Item No. 1 Town of Atherton

CITY COUNCIL STAFF REPORT – REGULAR AGENDA

**SUBJECT: RECEIVE CIVIC CENTER PROJECT UPDATE; REVIEW,
DISCUSS AND PROVIDE DIRECTION ON DESIGN CHANGES
AND VALUE ENGINEERING OPTIONS FOR THE LIBRARY;
DIRECT STAFF TO REQUEST A RE-DESIGN PROPOSAL FROM
WRNS STUDIOS; RECEIVE UPDATE ON PROGRESS OF VALUE
ENGINEERING OPTIONS FOR THE ADMINISTRATIVE/POLICE
BUILDING; RECEIVE, DISCUSS AND PROVIDE DIRECTION ON
FUNDING ISSUES RELATED TO THE OVERALL PROJECT; AND
PROVIDE DIRECTION ON POTENTIAL DEMOLITION OF
LIBRARY BUILDING**

- Attachment 1: PMC Meeting Summary 7-18-18
- Attachment 2: PMC Meeting Summary 7-25-18
- Attachment 3: PMC Meeting Summary 8-1-18
- Attachment 4: PMC Meeting Summary 8-8-18
- Attachment 5: PMC Proposed Library VE Options 8-13-18
- Attachment 6: CD - Library Floor Plan
- Attachment 7: Proposed Admin/PD VE Options 8-13-18
- Attachment 8: Monthly Budget Summary

LEED Requirements

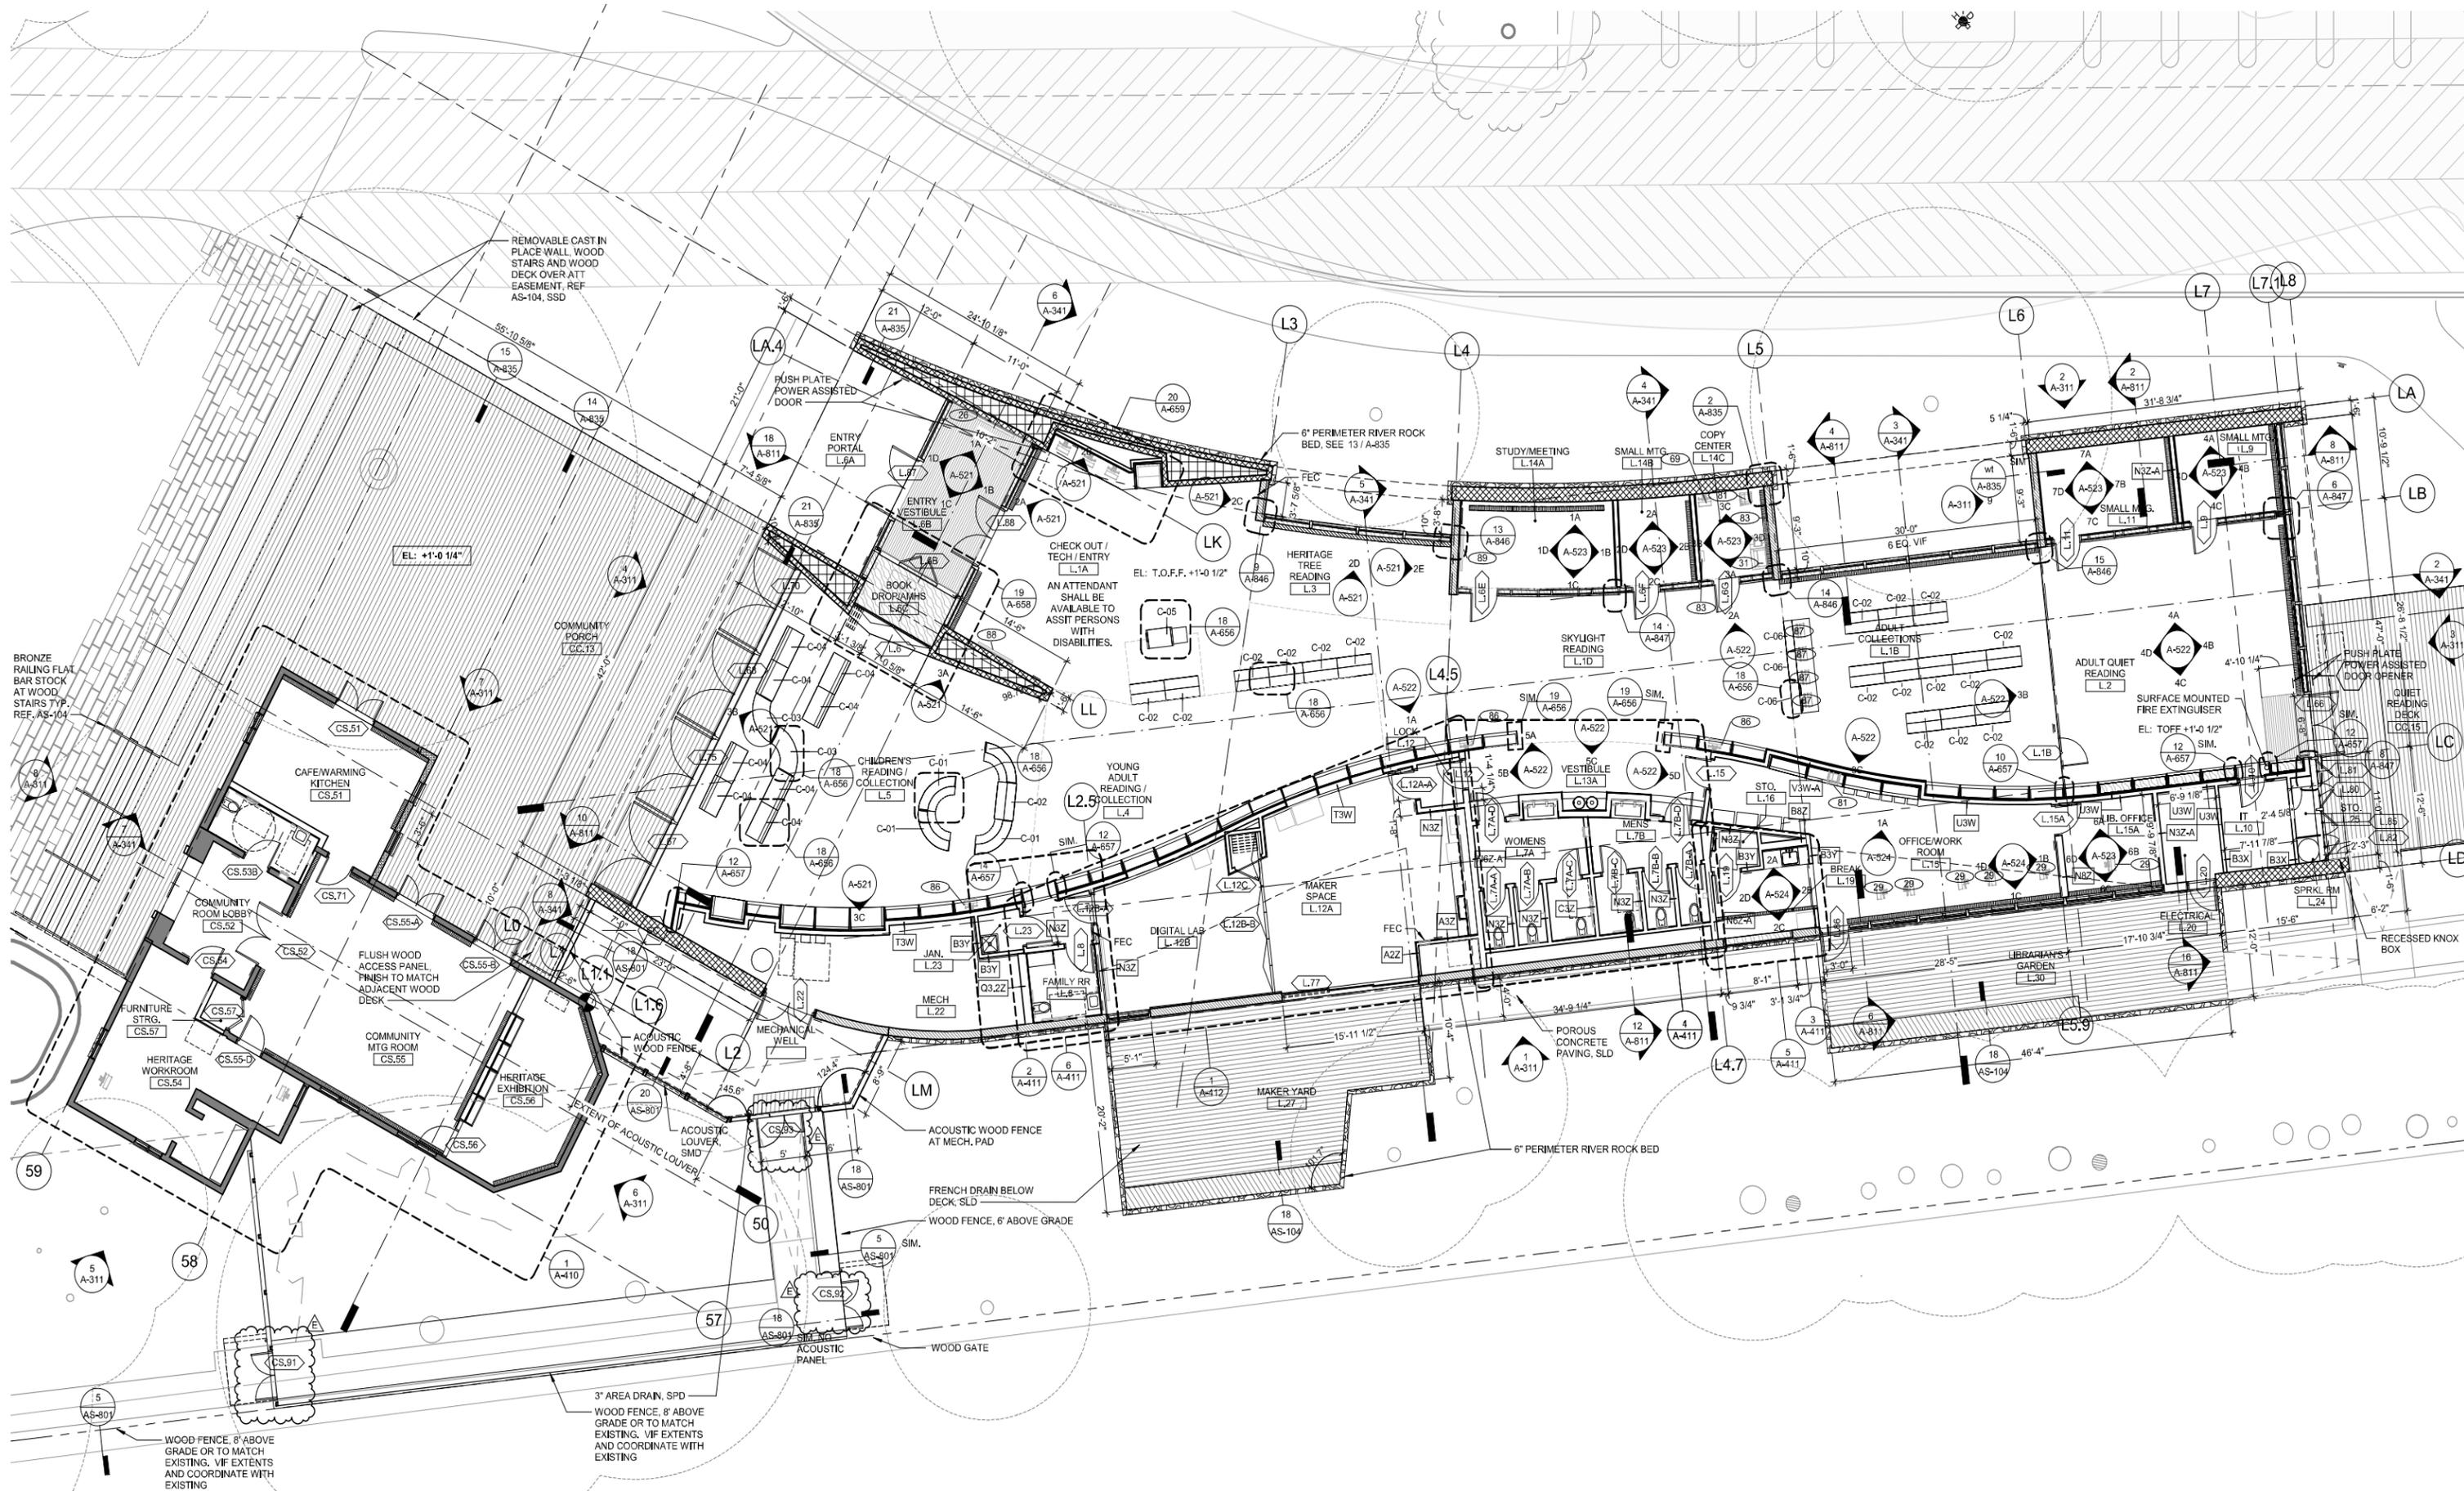
Delete or reduce LEED Requirements (not recommended)

(=) *1989 Waste Management Act already requires 50% diversion from landfill*
